## URGENT MEDICAL DEVICE CORRECTION MitraClip Delivery System

Commercial Name: MitraClip™ G4 Clip Delivery System, MitraClip™ NTR/XTR Clip Delivery System (reference Appendix A for model numbers)

FSCA-Identifier: Clip Delivery System September 8, 2022

Manufacturer: Abbott Vascular Santa Clara, CA

Figure 1: Fluoroscopic imaging of a Clip opening while locked (COWL) at deployment (left) with CAD model overlay super-imposed (right)

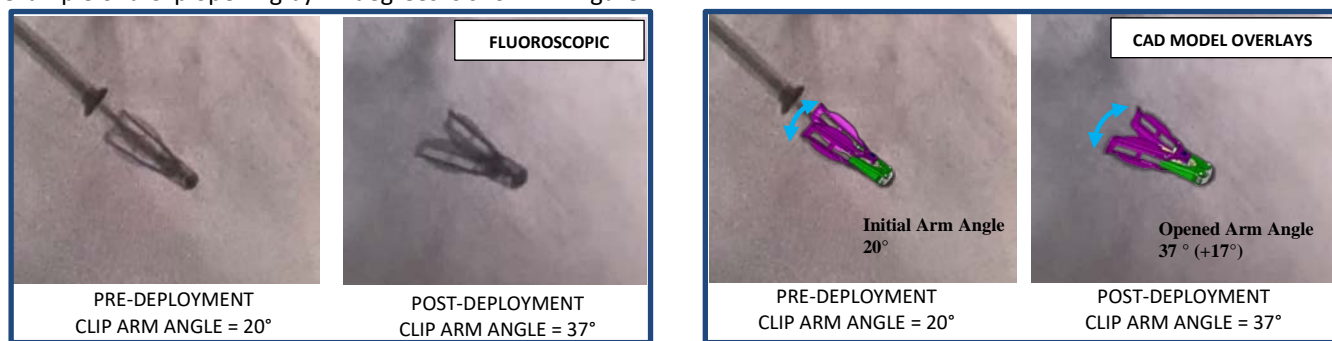
- EFAA is a procedural step where the user intentionally attempts to open a locked Clip to verify that the locking mechanism is engaged. EFAA steps occur during device preparation and prior to Clip deployment. An EFAA failure occurs if the Clip opens during this verification step.
- COWL describes when the Clip Arm angle increases post-deployment. In these cases, users observe a slippage in the lock, resulting in an Arm angle greater than 10 degrees from the angle observed at deployment. This change in arm angle after deployment can be identified through fluoroscopy (see example in Appendix A, Figure 1).

An example of a Clip opening by 17 degrees is shown in Figure 1.

When the Clip is locked, the locking mechanism is designed to more fully engage as the Grippers push down on the Clip Arms. The constant force applied by the Grippers secures the leaflets within the Clip. During a COWL event, the lock slips as the Clip Arms open by a given degree. In any case where significant residual MR is observed after Clip deployment, a second Clip should be considered and implanted in accordance with the IFU.
